STAFF DESIGN COMMISSION REPORT

Project Name: 13 E. Miner Street
Project Address: 13 E. Miner Street
Prepared By: Steve Hautzinger

DC Number: 15-097
Petitioner Name: Frank Panzarino
Petitioner Address: 904 S. Edgewood Lane
Mt. Prospect, IL 60056
Meeting Date: August 11, 2015

- 1. Approval of the proposed architectural design for a new apartment building with indoor parking in the (B-5) Downtown Zoning District.

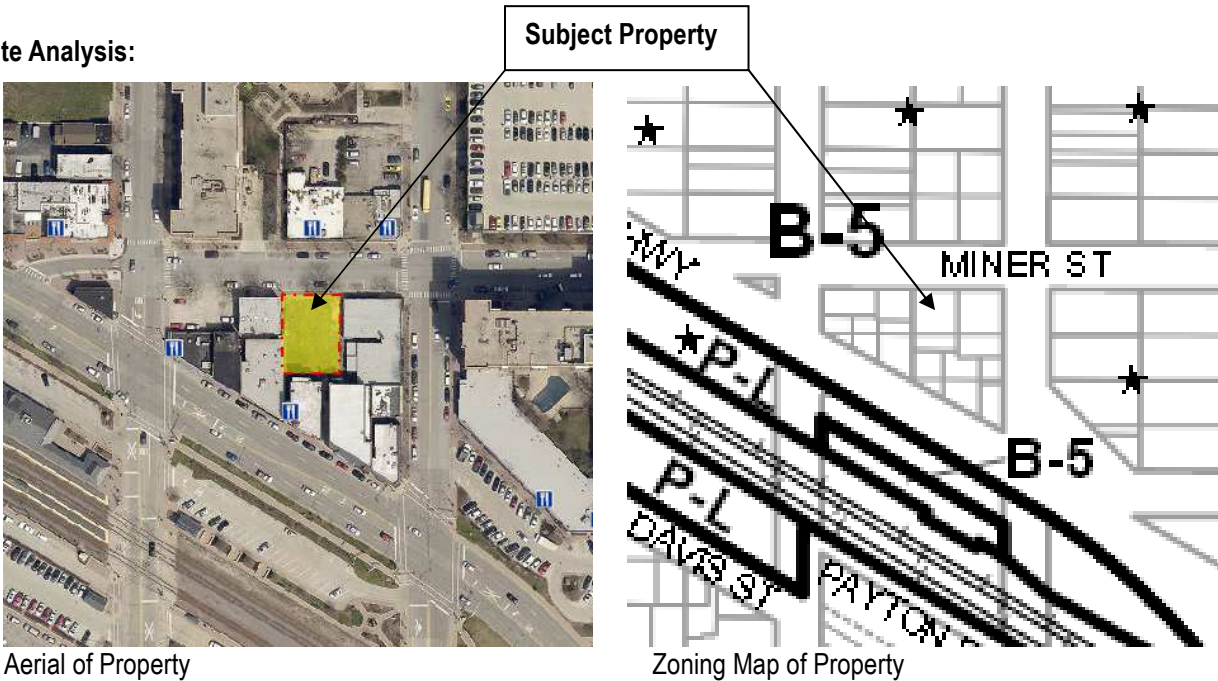
Front (north) Elevation. The composition of the front elevation is well done with nice symmetry, recessed balconies, and rich materials. However, the following revisions are recommended to enhance the design:

4. Retail storefronts should be added on the first floor to add visual interest at the sidewalk level, and to enliven this area of the Downtown.
5. The small arches and keystones above the windows and balcony doors are weak. Consider a straight, stone lintel detail with a heavier appearance in lieu of the arch detail.

6. The brick wall area above the top floor windows is blank and void of detail. Consider adding more details in this area such as decorative brick and stone detailing.

7. The arched cornice at the top of the building and arched lintel above the first floor garage door are awkward. Consider omitting the arch, and providing a built-up linear stone detail instead.

8. The proposed railing detail at the roof deck level is a nice detail, but it is proposed to be set back from the front wall. Consider moving this detail forward to be in line with the front wall so that it is more visible and aligns with the balcony railings below.

9. The two brick colors are too similar in appearance and do not enhance the design. Consider omitting one of the brick colors for a more cohesive appearance.
